# DEVELOPMENT REVIEW COMMITTEE (DRC) COMMENT REPORT

**PROJECT NAME:** 17th Street Quay

**CASE NUMBER:** UDP-S22015

**REQUEST:** Site Plan Level III Review: Waterway Use and Conditional Use for Mixed Use Development with Allocation of 358 Residential Flex Units, 12,500 Square-Feet of New Commercial Use, and 72,902 Square-Feet of Existing Commercial Use with an Associated Parking Reduction

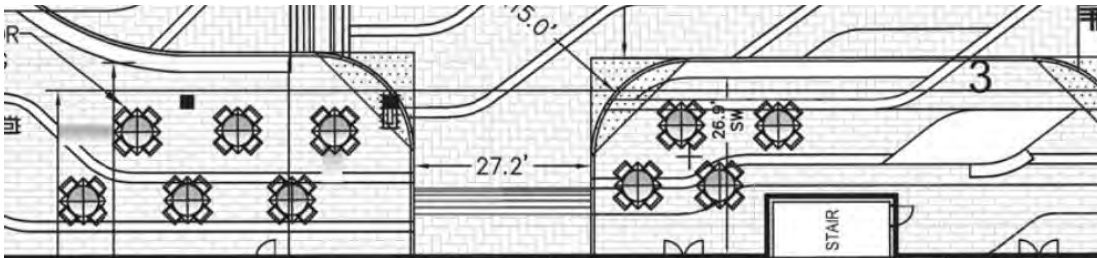
- g. The areas currently designated as plazas on the east, west, and north frontages function as pedestrian thoroughfares. Update Sheet No. X4, Open Space Exhibit and the Site Plan data table on Sheet No. -C0, to reduce the square footage provided for public pedestrian plaza space. Sidewalks cannot be considered plazas. Plazas are open aired and semi-enclosed gathering spaces that function as a centralized hub, providing a connective focal point for pedestrian activity and land uses. It is highly encouraged to reconfigure the east and west frontages to include plaza spaces that create a unique identity and connect existing and proposed uses through functional plazas which will help integrate the different uses.

An existing example of a plaza is located on the northwest corner of the site, between Buildings B, D, and E, offering a focal point of connectivity between three separate buildings, with a high arched arcade that provides shading and design elements. Moreover, the arcade connects to a passthrough to the rear waterway and functions as a terminus for Building A and C, based on sites 90-degree configuration. It is highly encouraged to redesign the areas currently labeled "plaza".

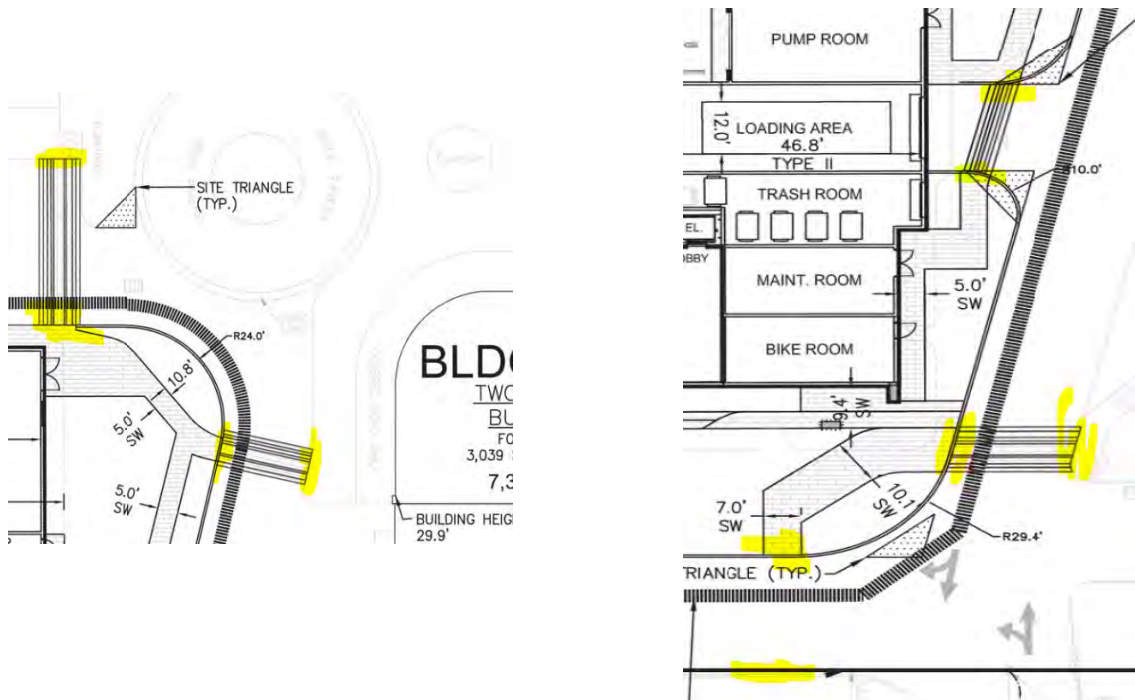
- 4. Consider reconfiguring or redesigning the outdoor seating area located on the south east corner of the building to create a pedestrian clear pathway on the sidewalk. Additionally, provide curb cuts for sidewalk accessibility along the loading zone driveway and parking garage entrance.

14) Provide the following changes on elevations:

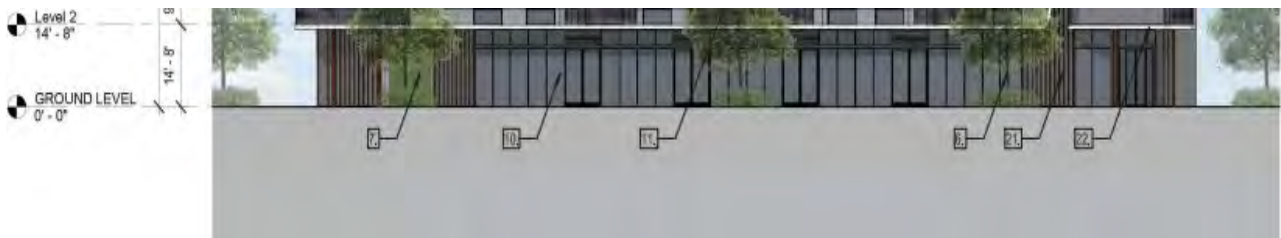
- a. The ground level of the building frames the public realm and assists in creating an animated built environment. The base of the building should also support the scale and massing of the structure. Based on the height and scale of the structure, increase the first floor to align with the size and massing of the building along N.E. 17th Street, wrapping the height and associated features around the corners of the structure to align with the sightlines from the right-of-way.

- b. Corners are prominent focal points, aiding to the structure's interaction with the built environment. The southwest and southeast corners require more prominent features that aid in creating building identity. Both Comment 14.a and 14.b, are interrelated and should be handled as one unified issue needing to be addressed.
